# 45 McLaren St

## North Sydney

Response to Council RFI

February 2024

# Deep soil area

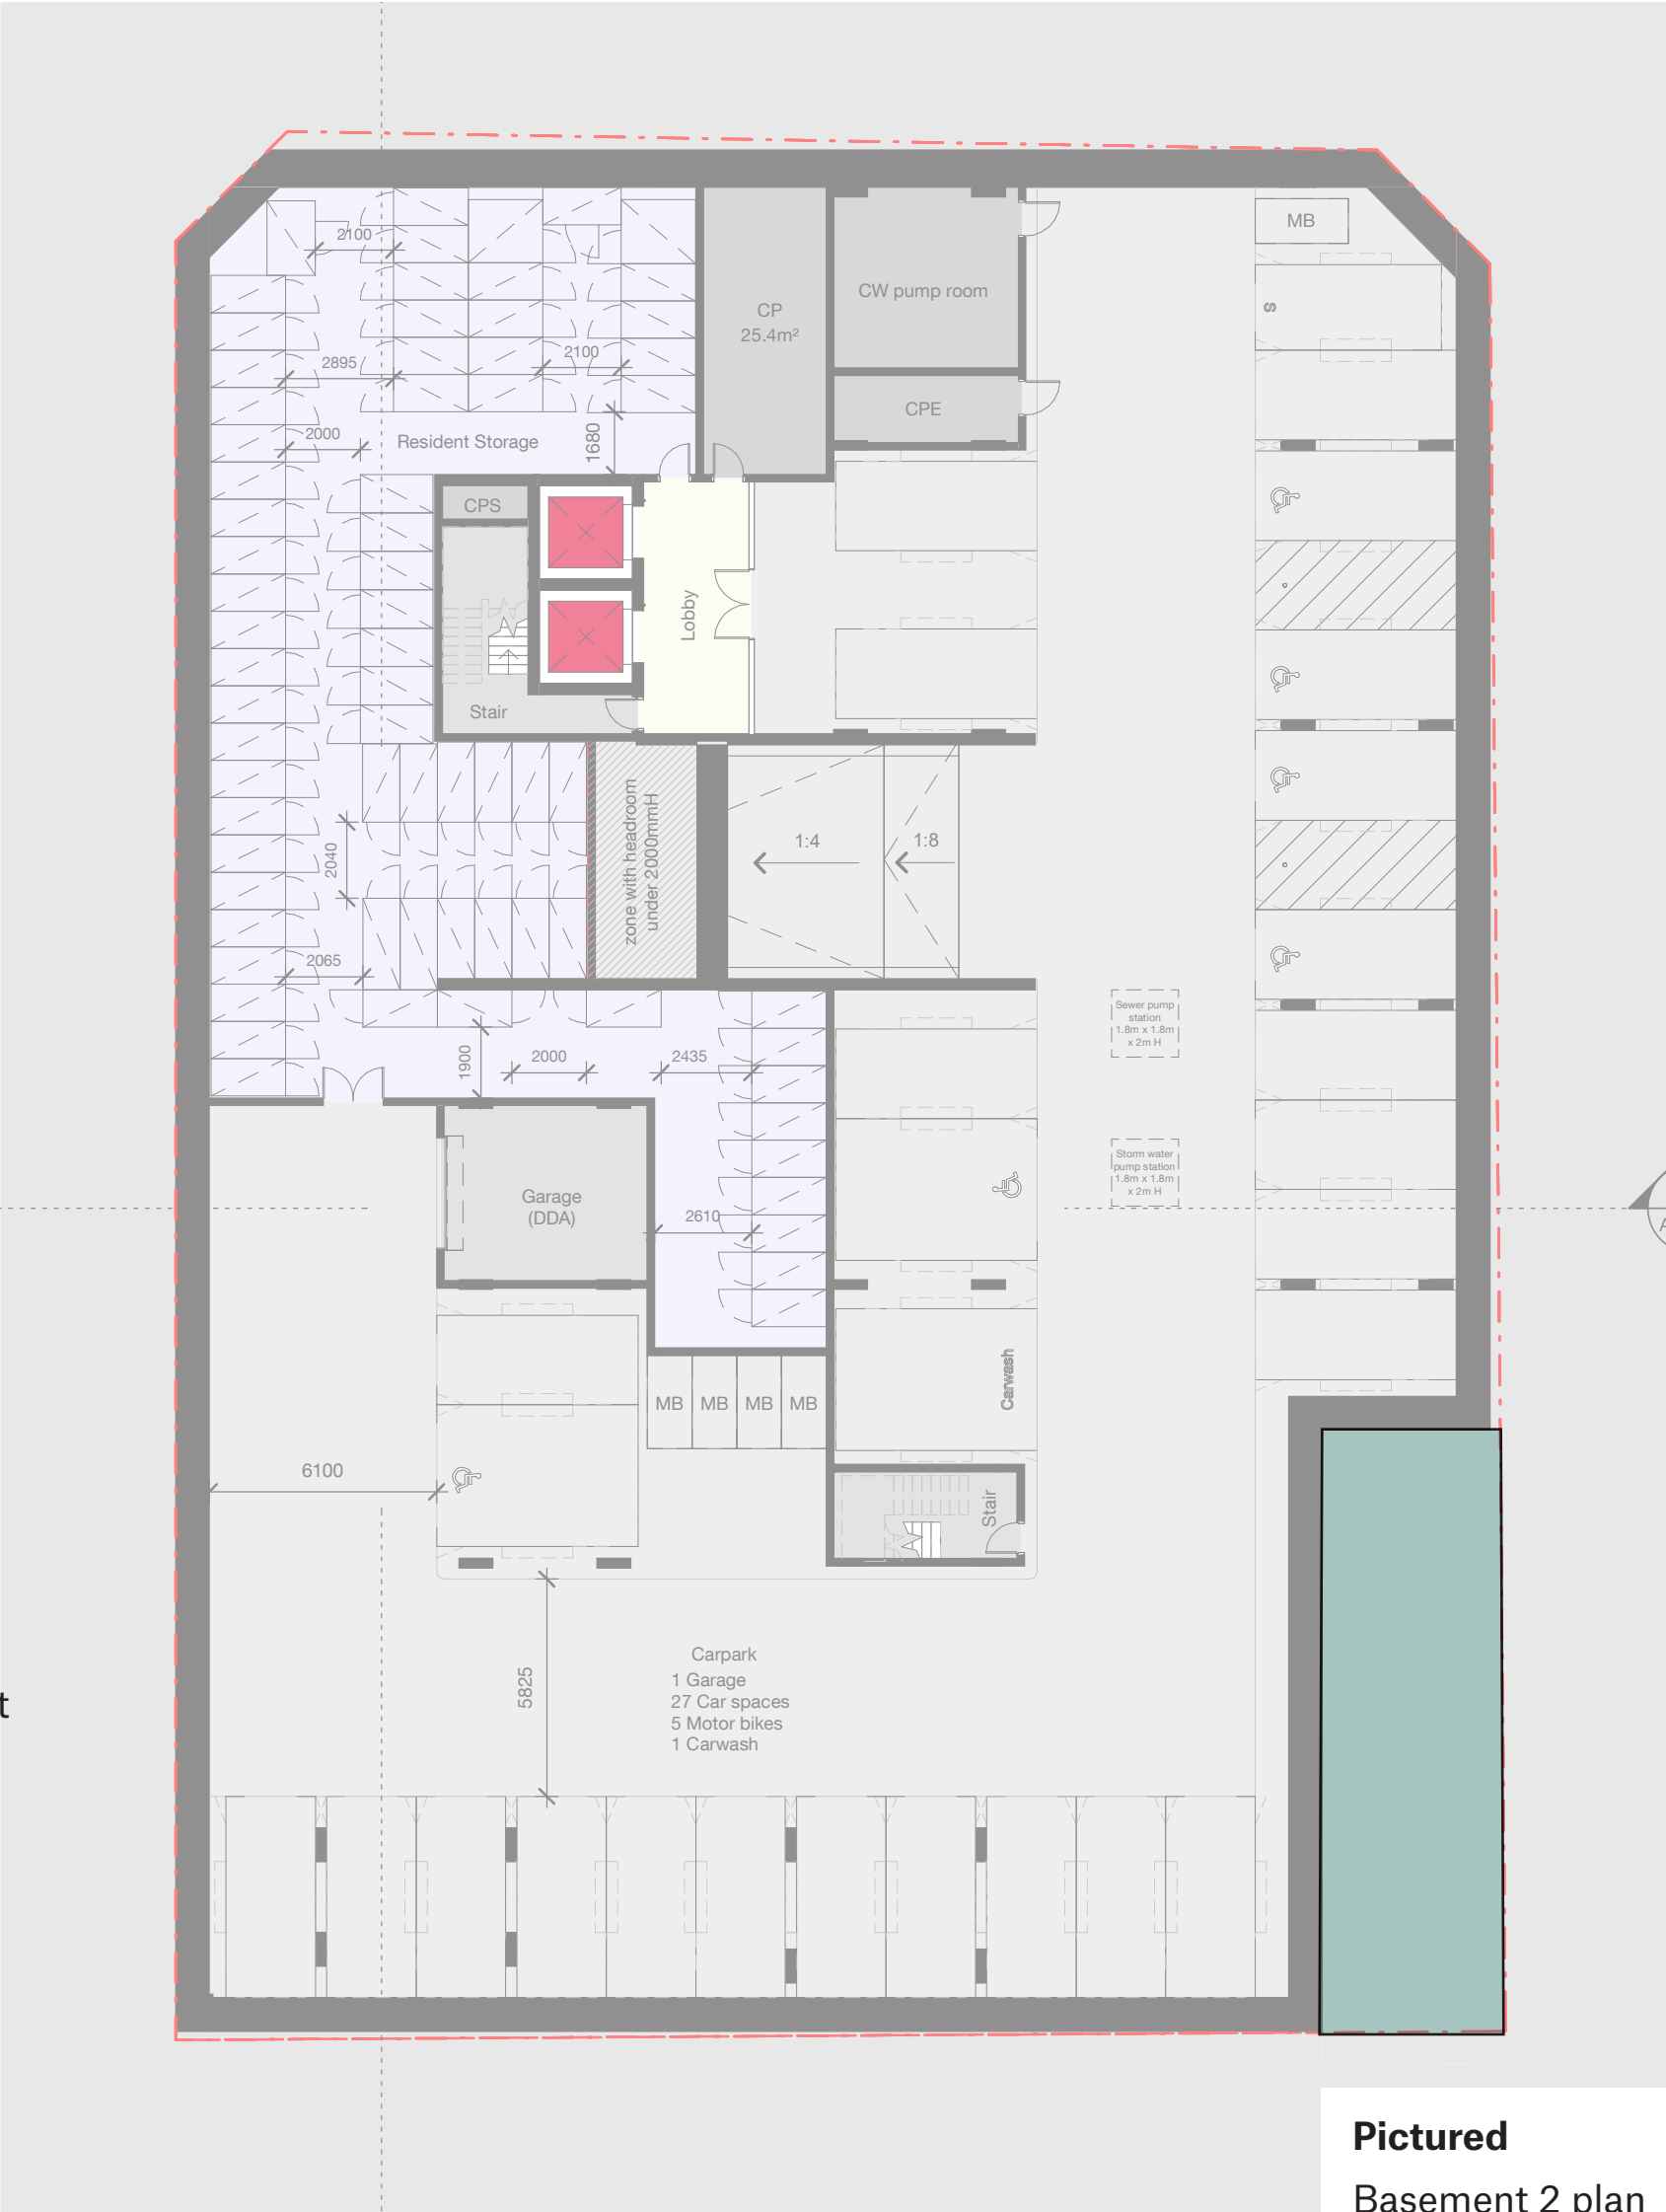
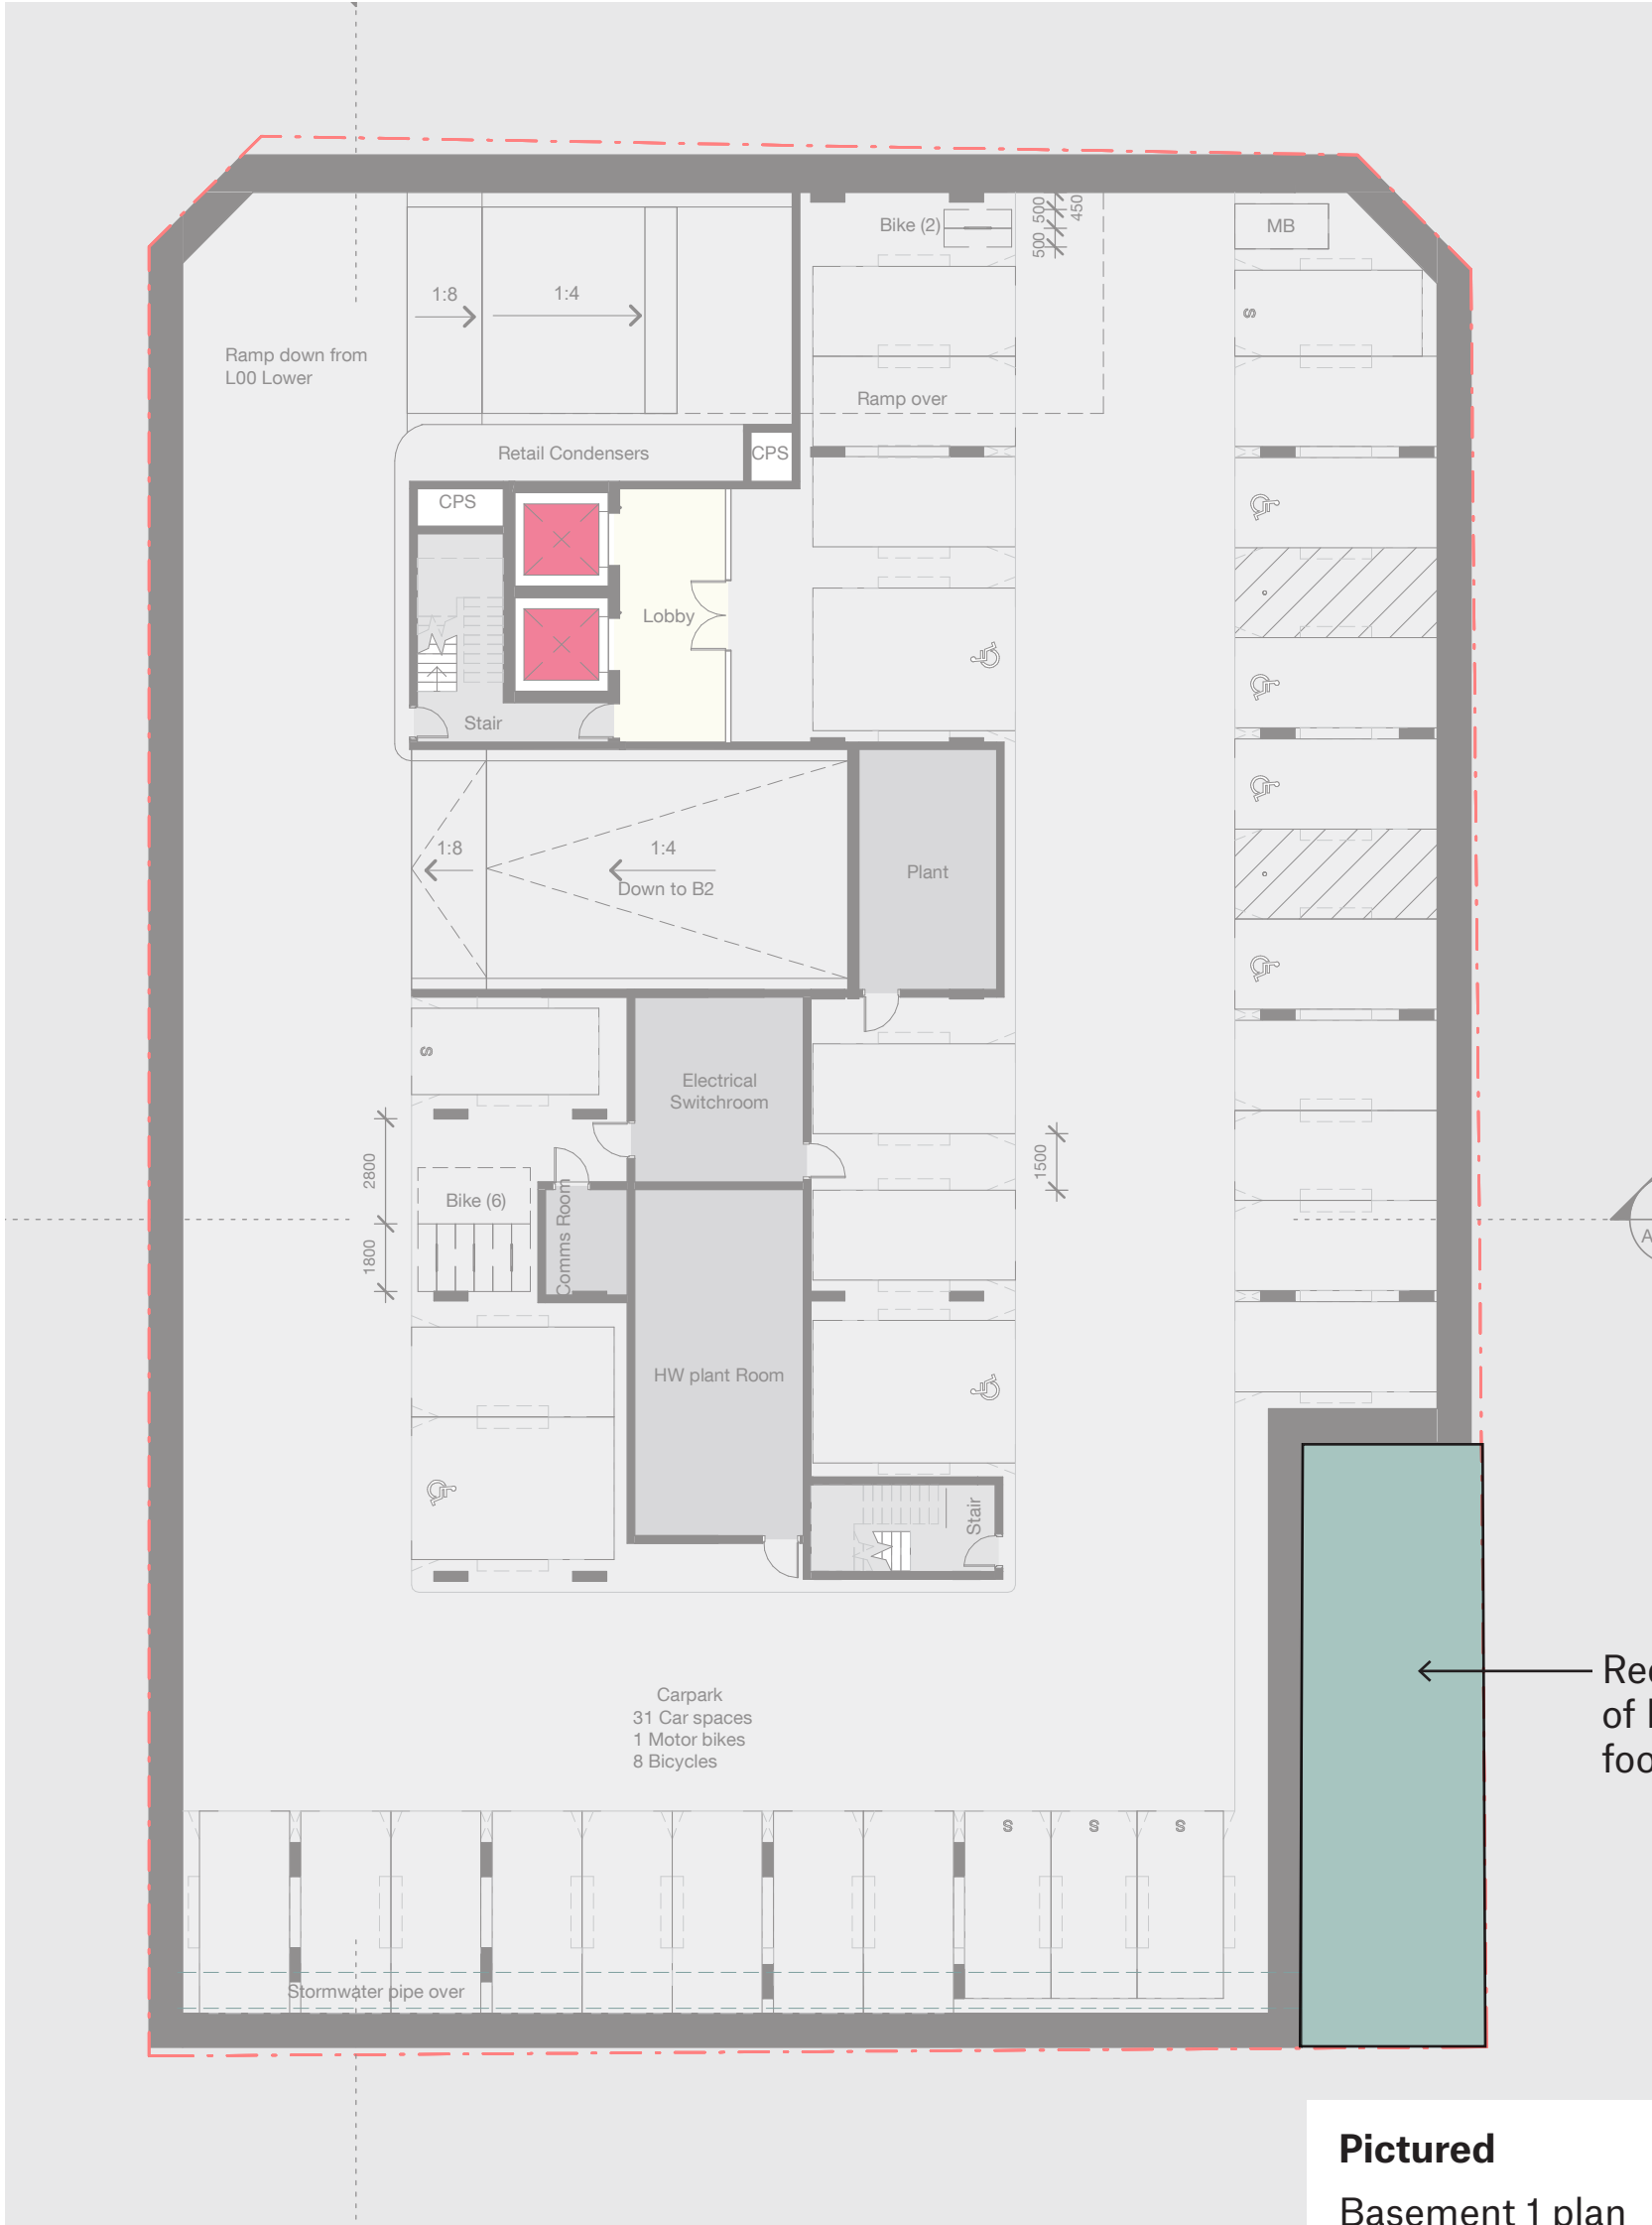
*A **lack of deep soil** was noted as one of the key site constraints. Council recommend increasing the deep soil area by reducing building footprint.*

- Increase the setback on through site link to introduce built planter zone with depth ranging from 500mm deep to 4m deep - allowing small to medium sized trees (approximately **45m<sup>2</sup>**).
- Reduction of basement footprint to introduce a new deep soil zone along Walker Street, replacing the solid planter box and wall with a deep soil zone capable of supporting a small to medium size tree.(approximately **78m<sup>2</sup>**).

- Reduction of basement footprint to increase deep soil area to the development (approximately **78m<sup>2</sup>**).
